Sumter City-County Planning Commission

January 25, 2012

SD-11-02, Moonlite Village Phase 2 – Old Camden Highway (County)

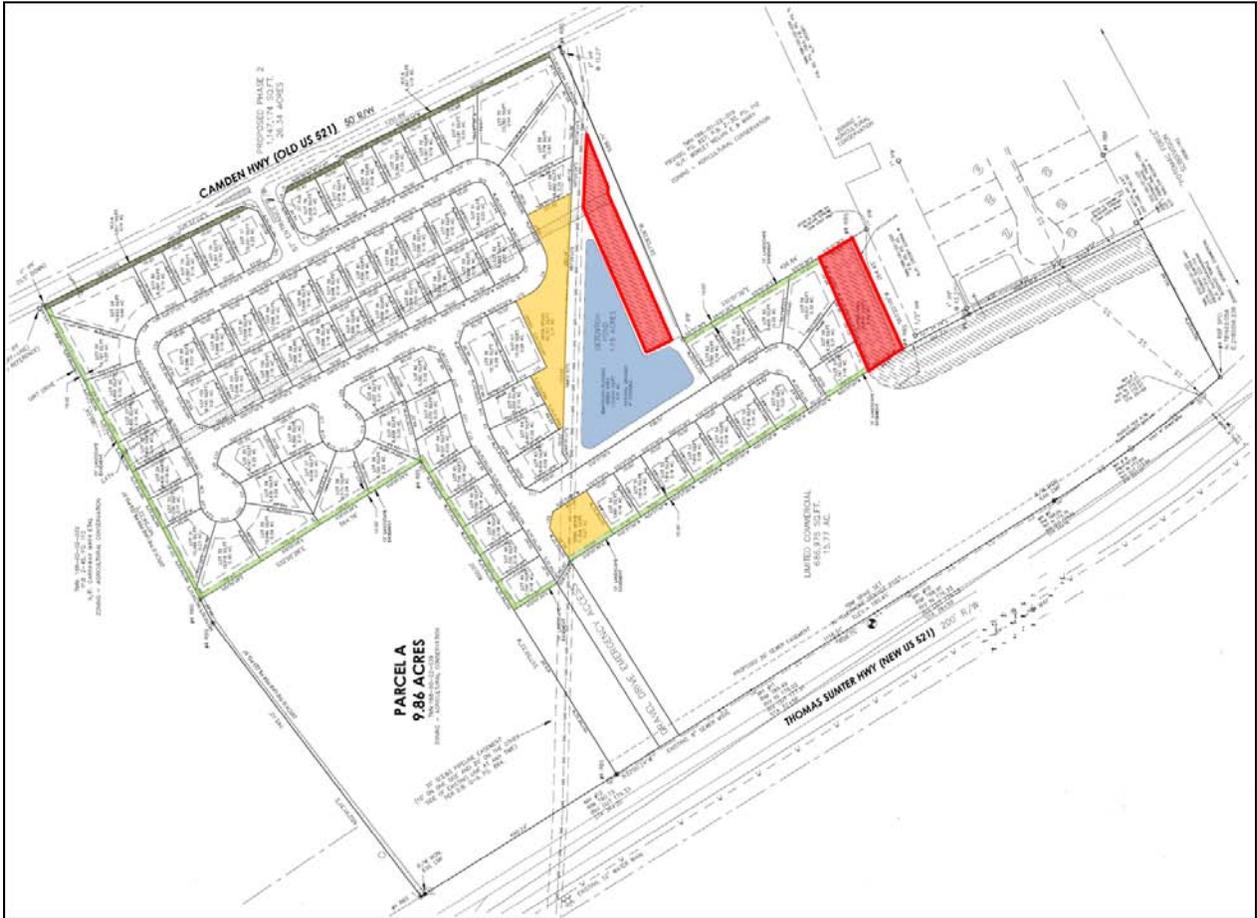
This note does not meet the requirements of Section 8.d.3.b of the Ordinance. At minimum, a formal tree survey must be submitted for on-site Staff review to determine whether there are any protected species within the ditch line area that must either be preserved or mitigated through provision of additional landscaping.

As shown in the graphic above, the areas indicated in light green have been set aside as 10 ft. landscape easements designated for the installation of an evergreen buffer strip. The area indicated in darker green is an independent 10 ft. wide 0.15 acre parcel that will be owned by the HOA and planted as a buffer between the development and Camden Hwy. street frontage. Areas indicated in red are areas protected under recorded covenants with the US Army Corps of Engineers as wetlands remediation areas and are not to be disturbed; and the areas shaded in orange are community open space and the blue highlighted area is the stormwater management pond.

In accordance with Section 8.d.1, landscaping shall be provided as part of site plan and subdivision designs. Planning Staff recommends that the designated buffer easements and HOA owned buffer parcel be planted with the following minimum plantings:

- One canopy tree every 50 ft.; minimum 2 in. caliper and 6 ft. tall at time of planting;
- 1 understory tree centered between every canopy tree; minimum 1 ½ in. caliper and 5 ft. tall at time of planting;
- 10 evergreen shrubs every 50 ft. spaced 5 ft. to 7 ft. on center. Selected species shall meet a minimum height of 6 ft. at maturity and shall be a minimum size of 3 gallons and 30 in. tall at time of planting.

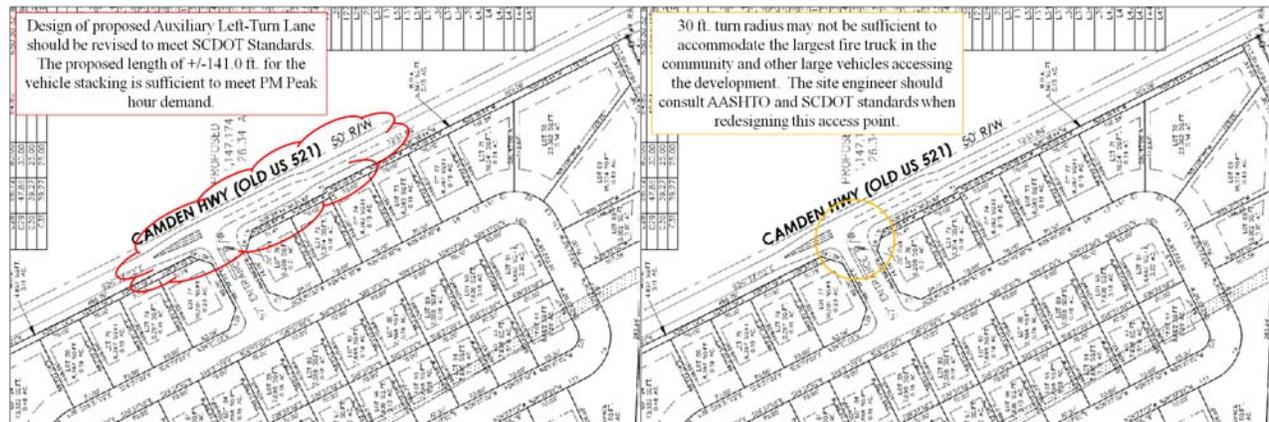
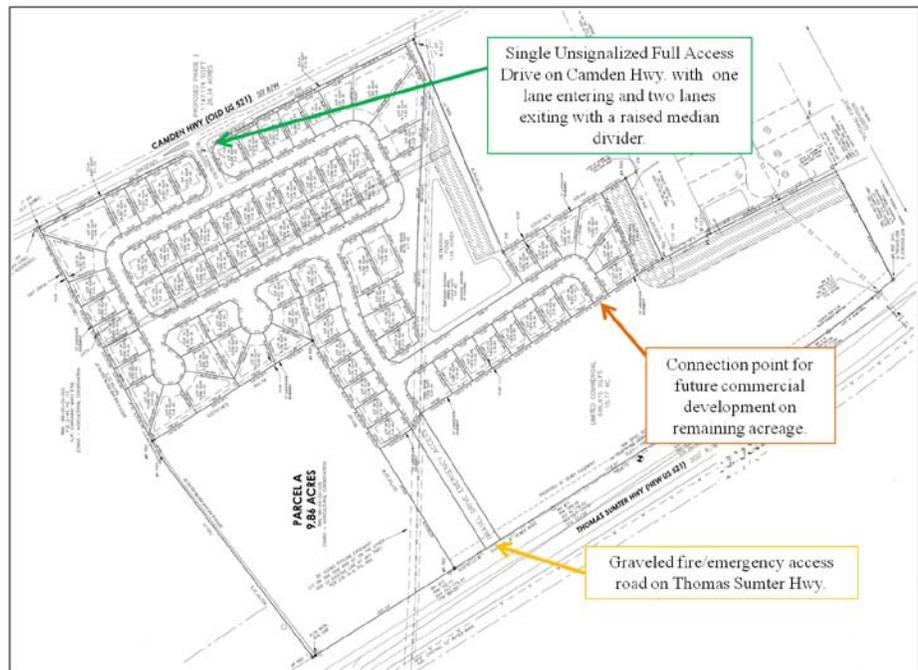
The applicant has already modified site access to the subdivision in accordance with the TIS recommendations by consolidating the Camden Hwy. driveways as shown in the graphic to the right.

applicable design criteria to provide sufficient queuing capacity for both entrance movements and exit movements. There are still design issues that must be addressed as shown in the graphics below but overall the concept is in keeping with the recommendations of the TIS.

3. The single subdivision access on Camden Hwy. with one entrance lane and dedicated left-turn and right-turn exit lanes with a raised planted median shall be installed prior to issuance of the first construction permit for any dwelling.
